MANDATORY SERVICE BULLETIN

MSB 50-013

Replacement of the propeller de-ice brushes bracket bolts.

WI-MSB 50-013

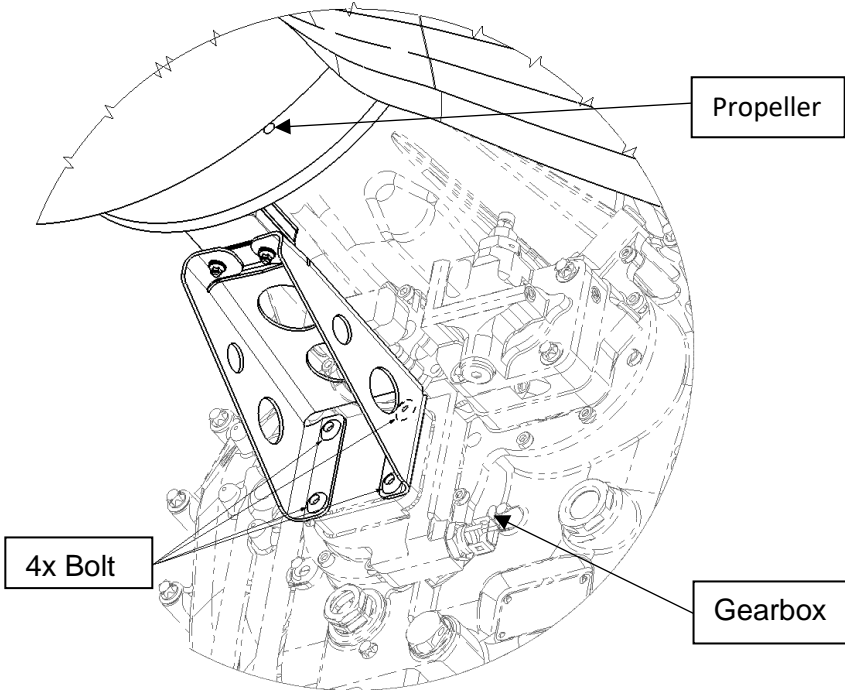
The effective thread length of the bolts that attach the propeller de-ice brushes bracket to the engine gearbox are shorter than specified by the engine manufacturer. This can cause tear out of the aluminum thread in gearbox housing and imperfect seal of the accessory drive cover and may subsequently lead to leakage of gearbox oil. This Service Bulletin describes replacement of these bolts with the right length as specified by the engine manufacturer as a precautionary action.

| 2 | <p>Replace each of the 4 bolts that attach the propeller de-ice brushes bracket to the gearbox, one by one, with the ISO7380-M8x16-10.9-BZP bolts.</p> <ul style="list-style-type: none"> • Replace on bolt at a time • Apply Loctite 243 (or equivalent) to the bolts.  |

| Quantity | Part Number | Description |
|----------|------------------------|---------------------------------|
| 4 | ISO7380-M8x16-10.9-BZP | Hexagon Socket Button Head Bolt |

| 3 | Torque the bolts to 20 Nm \pm 2 Nm. |
